From: Orenak, Michael
Sent: Wednesday, September 7, 2022 5:38 PM
To: michael.tschiltz@gmail.com; Chisholm, Brandon Michael
Cc: Sebrosky, Joseph
Subject: NRC Comments on TIRICE draft guidance document.
Attachments: TIRICE Guidance DRAFT Rev D_final_NRC Comments_CLEAN.docx

**Technology Inclusive Risk Informed Change Evaluation (TIRICE)
For Non-Light Water Reactors**

Draft Report Revision D
Issued for Collaborative Review

Document Number
SC-16166-108 Rev D

Figure 2. Overall Plant Performance Change in Example 1

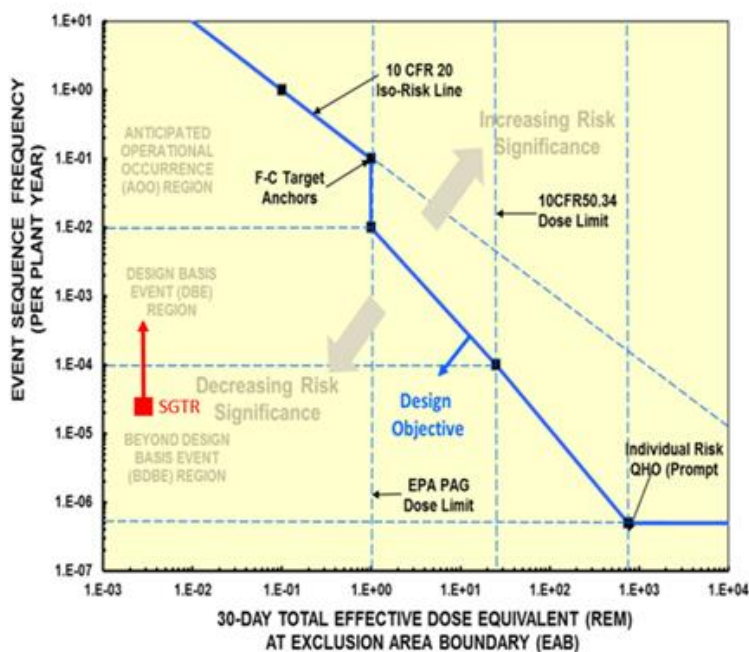
However, the figure seems to depict a change in event sequence frequency from BDBE to DBE. If this were the case, then a new DBA would be introduced based on this new DBE.

Please clarify.

Figure 3. Overall Plant Performance Change in Example 2

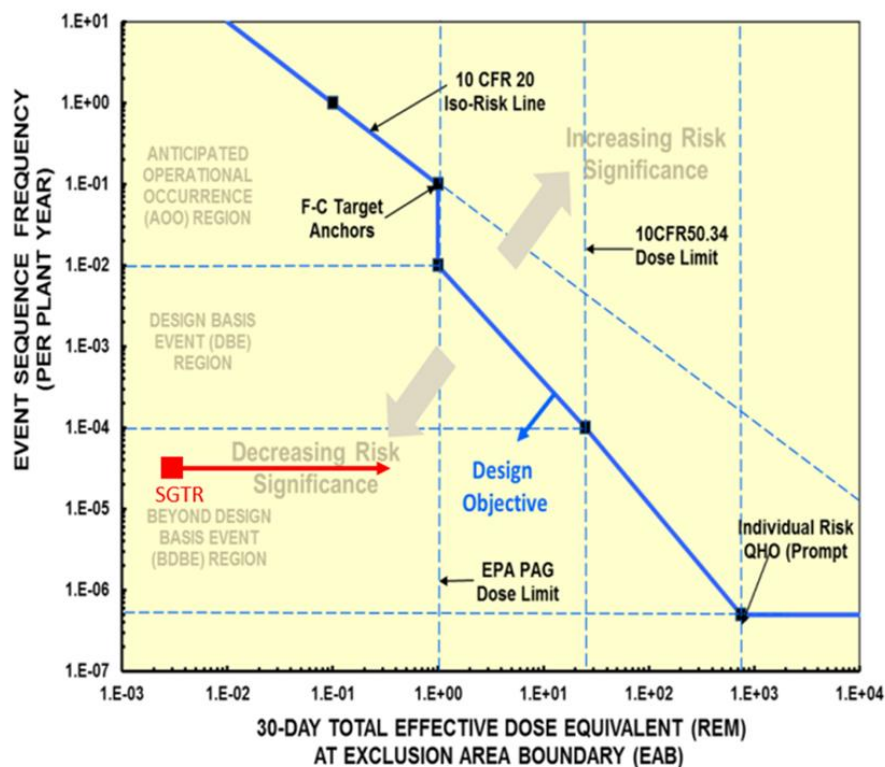
Commented [A60]: If this example event sequence was a DBA rather than the BDBE depicted, then this change would likely screen in based on the "more than minimal increase in consequences" scope of Criterion (c) below, correct?
